Access Compliance Report

Public Rights-of-Way

(Curb Ramps)

Intersection ID: 13708	Main Street: WEST_BV	Cross Street: WICKFORD_PL	Location: NE
ADA ID: DAA1585C1A01	Ramp Type: Perp	Initial Pass/Fail: Fail	Overall Compliance: No
Severity Score: 1.25			
Codes/Mitigation Info/Possible Solution		Field Measurements/Component Compliance

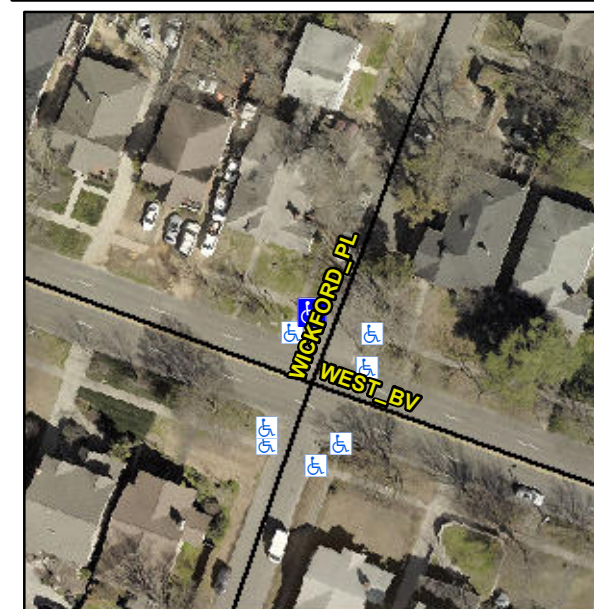
Not Found, R304.5.3

Compliance	Description	Data	Compliance	Description	Data
N/A	Ramp Length (in)	65.0	Yes	Ramp Slope (%)	5.5
Yes	Ramp Width (in)	61.0	No	Ramp XSlope (%)	4.0
N/A	Flare Type LT	N/A	N/A	Flare Type RT	N/A
N/A	Flare Slope LT (%)	N/A	N/A	Flare Slope RT (%)	N/A
N/A	Flare Traversable LT?	N/A	N/A	Flare Traversable RT?	N/A
N/A	Landing Length (in)	N/A	N/A	DWS Provided?	N/A
N/A	Landing Width (in)	N/A	N/A	DWS Contrast?	N/A
N/A	Landing Slope (%)	N/A	N/A	DWS Length (in)	N/A
N/A	Landing X Slope (%)	N/A	N/A	DWS Full Width?	N/A
N/A	Landing Curb? (Y/N)	N/A	N/A	DWS Offset (in)	N/A
N/A	Shared Landing?	N/A			
N/A	Gutter Ponding?	Yes	N/A	Gutter Slope (%)	N/A
N/A	Gutter Lip Ht (in)	2.0	N/A	Gutter X Slope (%)	N/A
N/A	Painted X Walk1?	No	N/A	Painted X Walk2?	N/A
	X Walk 1 Direction	To SE		X Walk 2 Direction	N/A
N/A	X Walk 1 Width (in)	N/A	N/A	X Walk 2 Width (in)	N/A
	X Walk 1 Slope (%)	4.0		X Walk 2 Slope (%)	N/A
	X Walk 1 X Slope (%)	0.0		X Walk 2 X Slope (%)	N/A

Remove & Replace Entire Ramp.
